Staff Report

Re: 9+9 Mixed Use Conditional Building and Site Design Review (PLNPCM2014-00890)

CONDITIONAL BUILDING AND SITE DESIGN REVIEW

PROPERTY ADDRESS: 932 E. 900 South

Site Plan
SCALE: 1" = 20'

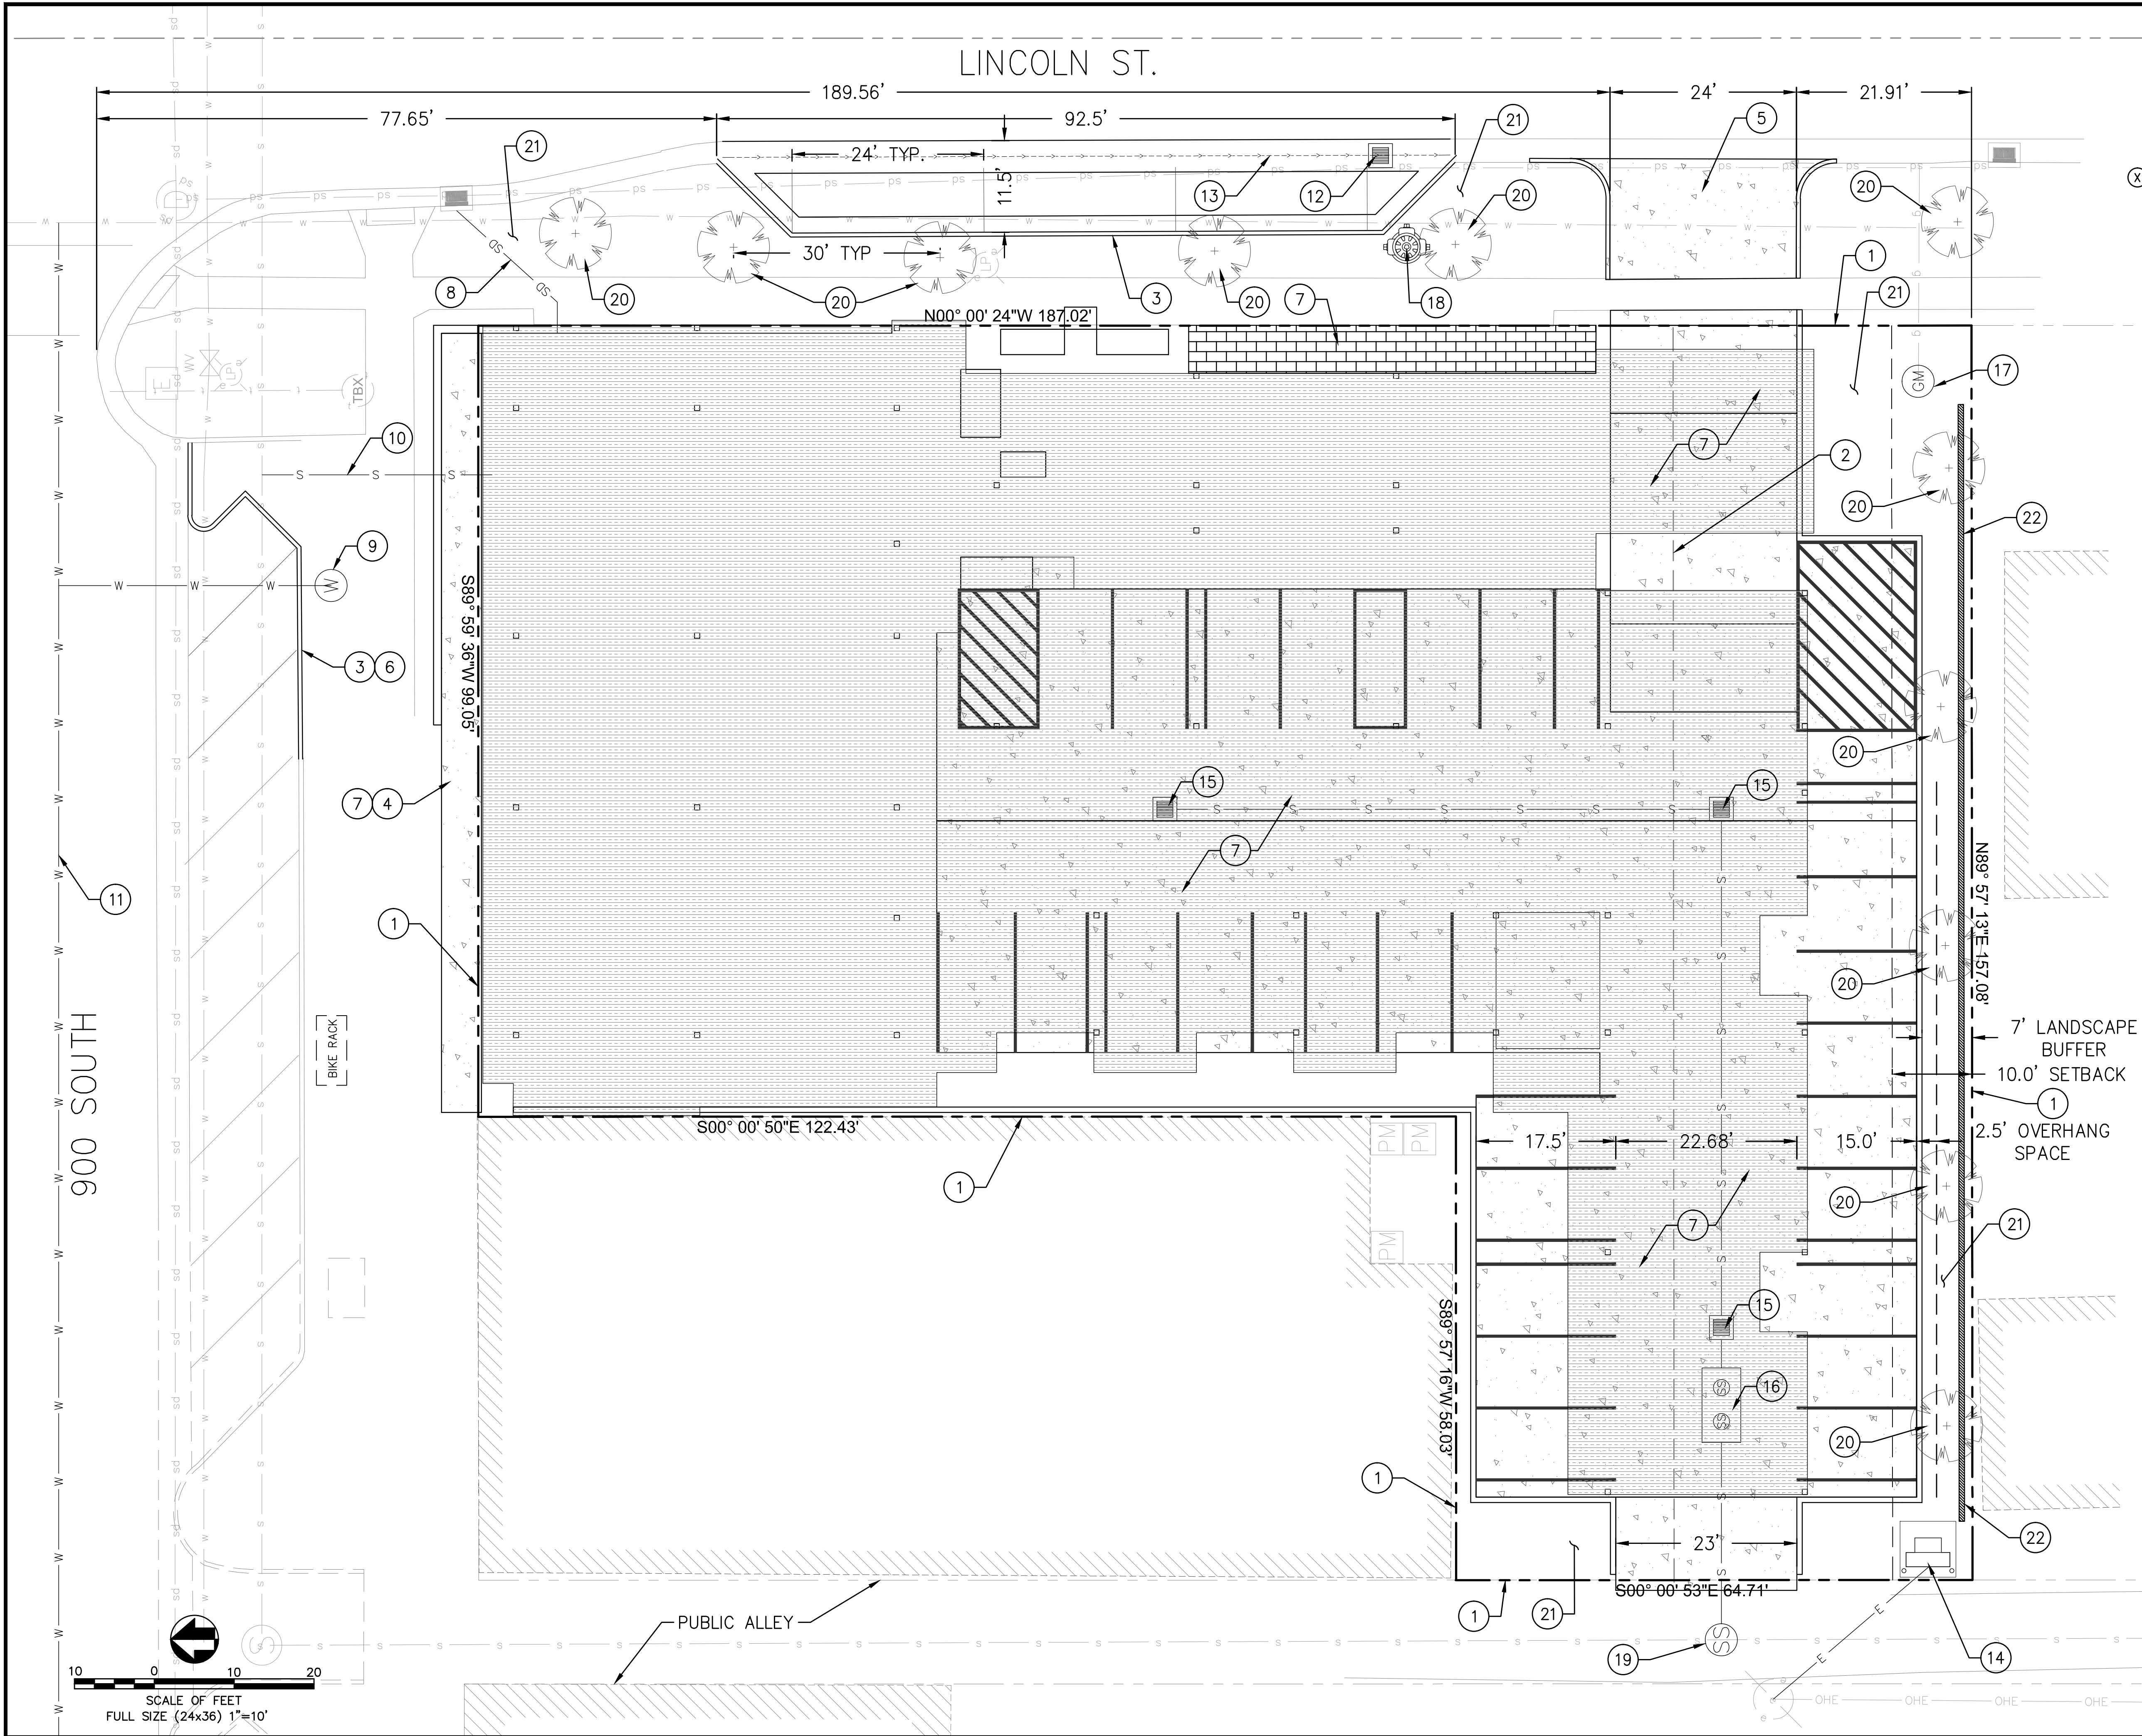
The proposed project will include a total of 25 parking spaces. These parking spaces will be located at the first floor level and they will all be accessed from Lincoln Avenue. Based on various reductions allowed through the Zoning Ordinance, the project is required to provide a minimum of 14 parking spaces. The reductions allowed are described in Section 21A.44.040.B.8 of the Zoning Ordinance. The applicant has demonstrated on the site plan that bike racks are located within 100 feet of an entrance to the business and therefore is allowed to exempt a total of 2,500 square feet of the retail building area from the parking requirements. Concerns have been raised by residents in the area that there is little to no on-street parking available today and most of those spaces are utilized by the existing residents. The concern is that this development will increase the demand for parking in the area and there will be less available for those who live and work there already.

A concern has been raised by a neighbor in the area about the rear yard setback. The building itself is located approximately 20 feet from the rear property line and a seven foot landscaped setback has also been provided. Both of these items are in compliance with the standards of the Zoning Ordinance. Staff will agree that the manner in which the site plan was drawn does make it seem like the building is closer than the minimum setback as a four foot tall retaining wall and required light proof fence are shown on the site plan. A total of five new trees will also be installed in the landscaped area along the rear property line to help screen the building and parking area from the residential property located directly to the south.

Staff has noted that the proposed required parking area is accessible by one driveway or access point. While there is no requirement for more than one access point, it should be noted that having all vehicles entering and exiting the parking area through this one point will most likely increase the amount of vehicular traffic along Lincoln Street, since the current layout or configuration of the site has two access points. Currently there is one driveway along Lincoln Street and the other is along 900 South. The proposed parking area of 25 parking spaces is less than the approximate 35 parking spaces that currently exist on the site; however, all vehicular traffic will now be directed to one driveway. It should be noted that the City's Transportation Division has reviewed the project and did not have any objections to the proposed access or require a traffic study. The Central Community Master Plan includes a policy TRANS-2.1 states "minimize, through design review, that street design, pedestrian connections, building/parking areas, and land use designations do not create circulation conflicts between vehicles and pedestrians." Locating the vehicular access on Lincoln Street eliminates the existing drive approaches on 900 South, which are conflict points between pedestrians and vehicles entering the property. 900 South carries more pedestrian traffic due to the nature of the street, and should be viewed as the primary pedestrian street, where conflicts should be reduced.

East Side Elevation - Lincoln Street
 SCALE: 1/8" = 1'-0"

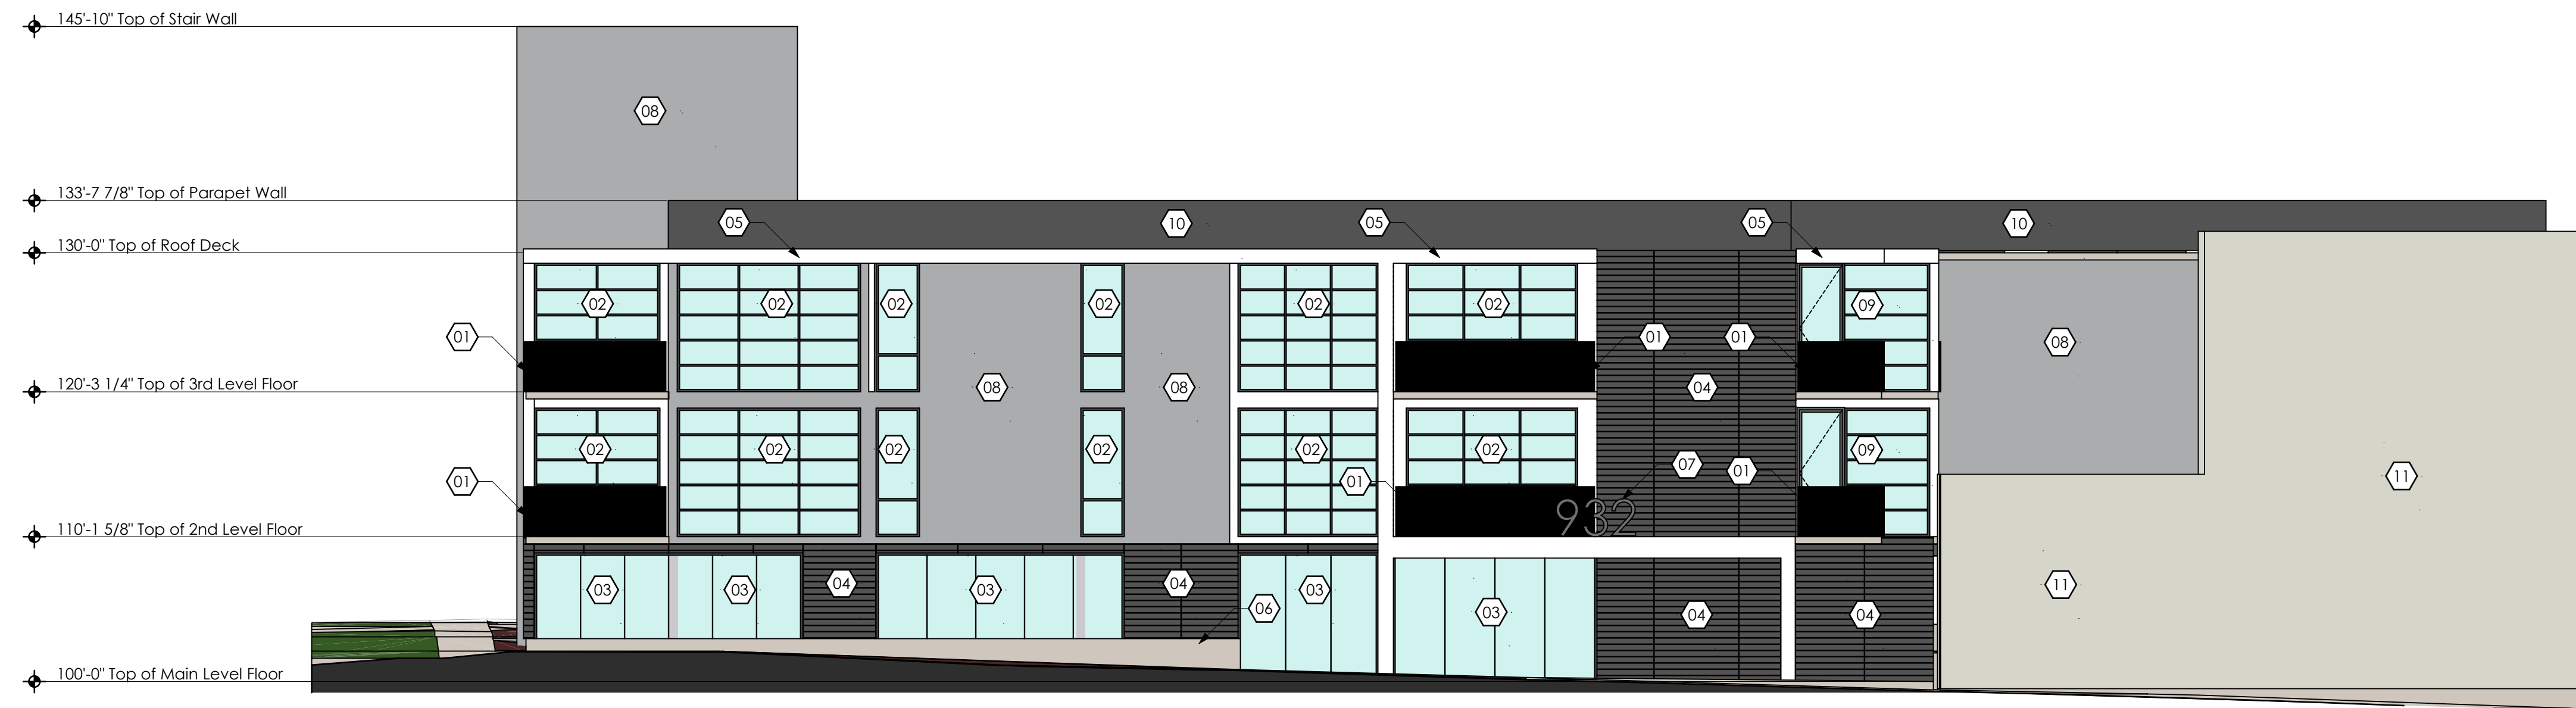
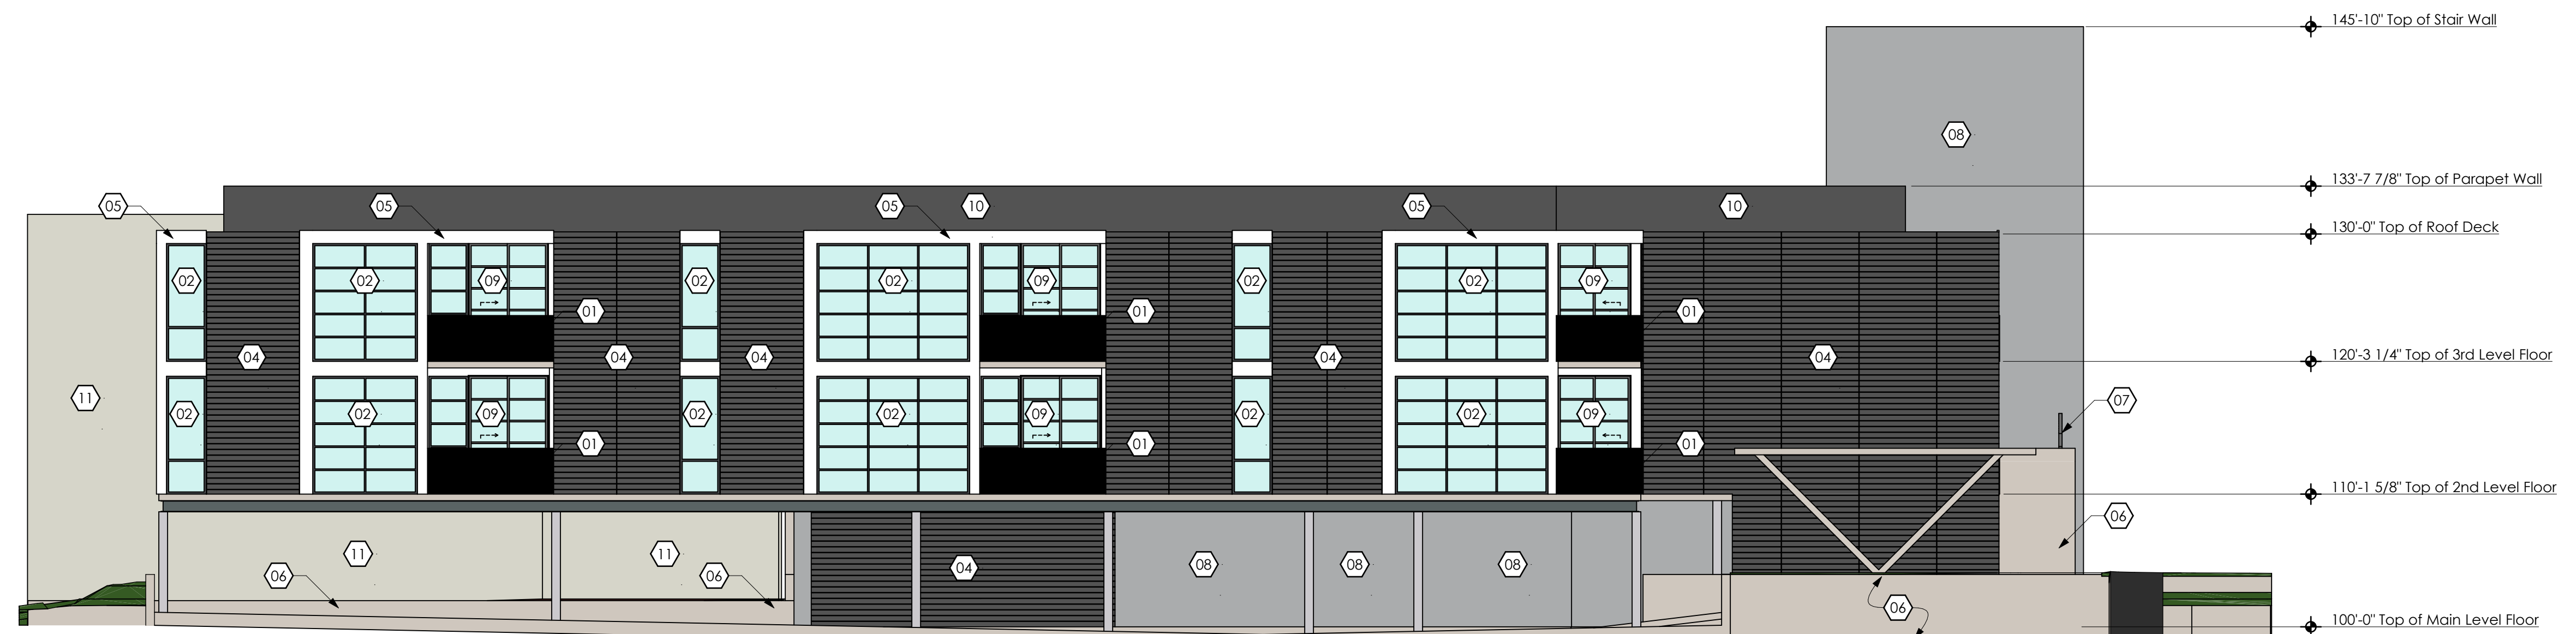
As noted in the project description, the building is designed to be 30 feet in height. However, it will have a parapet wall at the top to screen mechanical equipment that is approximately four feet tall. The Zoning Ordinance does allow a parapet wall for this purpose up to five feet in height. And, an elevator or stairwell bulkhead is provided that extends approximately 16 feet up from the roof deck height of 30 feet. This is also permitted per the Zoning Ordinance. Therefore, the building does comply with all height requirements of the Zoning Ordinance, but may appear taller than 30 feet.
